CONNECTICUT YANKEE ATOMIC POWER COMPANY

Haddam Neck Plant
Request for Additional Information on
Proposed Revision to Technical Specifications
Pressure/Temperature Limit Curves

Response to Requests for Additional Information

Pressure/Temperature Limit Curves Technical Specifications

Figure 3.4-1

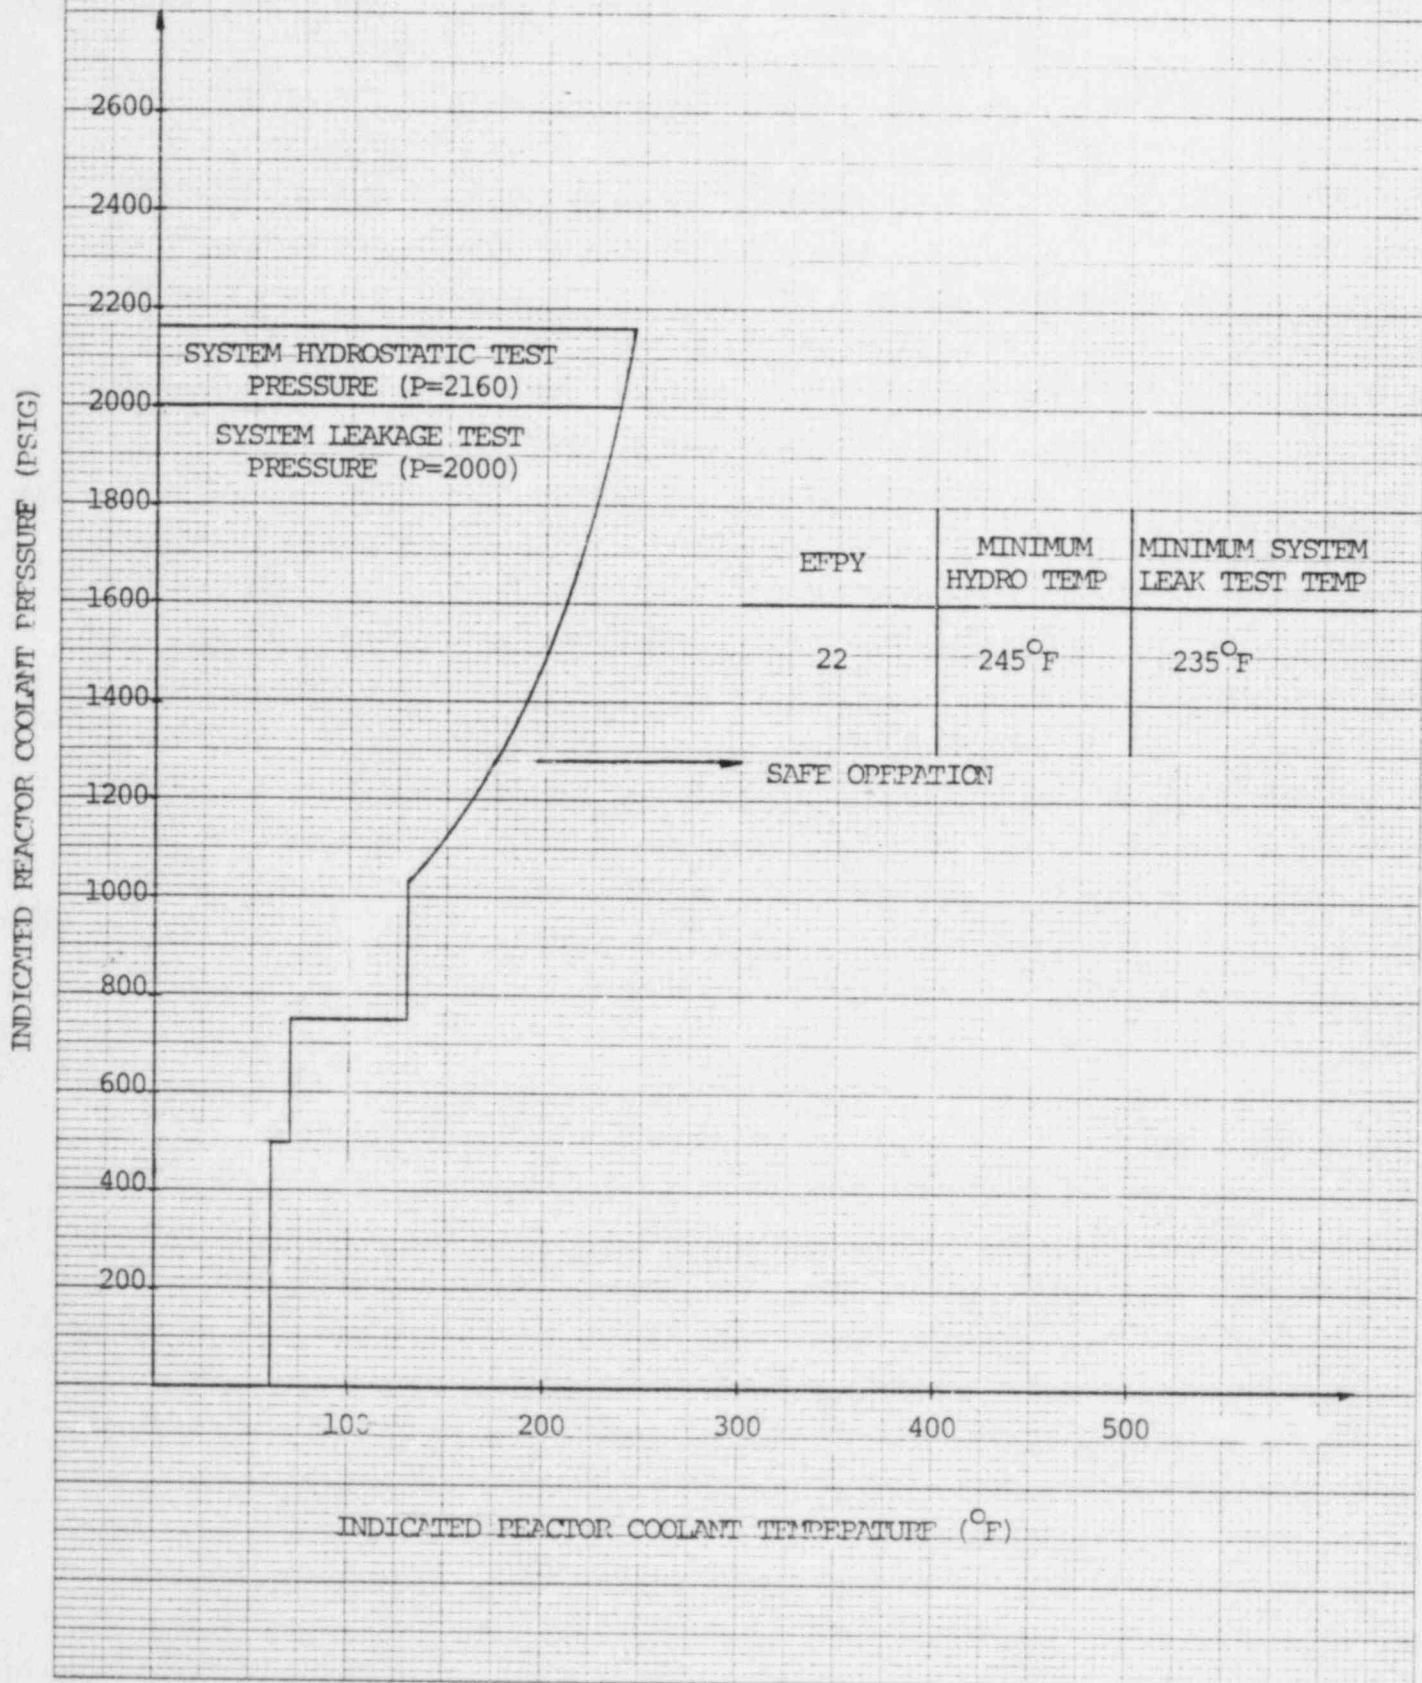
5.Q. Why isn't there a vertical lower limit line for bolt-up?

6.Q. Why isn't the flange protection line at 622 psi?

5.A. Historically, we have not had a requirement for a lowest bolt-up temperature. We will add a vertical bolt-up line at 60°F for both hydrostatic testing and operation. (Note that 60°F is equal to the higher of the reactor vessel flange RT_{NDT} and the closure head flange RT_{NDT}.) See attached curves.

6.A. From 10CFR50 Appendix G IV.A.2 says:

"In addition, when pressure exceeds 20 percent of the preservice system hydrostatic test pressure, the temperature of the closure flange regions that are highly stressed by bolt preload must exceed the reference temperature of the material in those regions by at least 120°F for normal operation, and by 90°F for hydrostatic pressure tests and leak tests...."

$$T = RT_{NDT}^* \text{ (of flange region)} + 120^{\circ}\text{F (or } 90^{\circ}\text{F for hydro)}$$

$$T = 40 + 120 \text{ (or } 90) = 160^{\circ}\text{F (130}^{\circ}\text{F for hydro)}$$

$$P = 0.2 (3750) = 750 \text{ psig}$$

See attached curves.
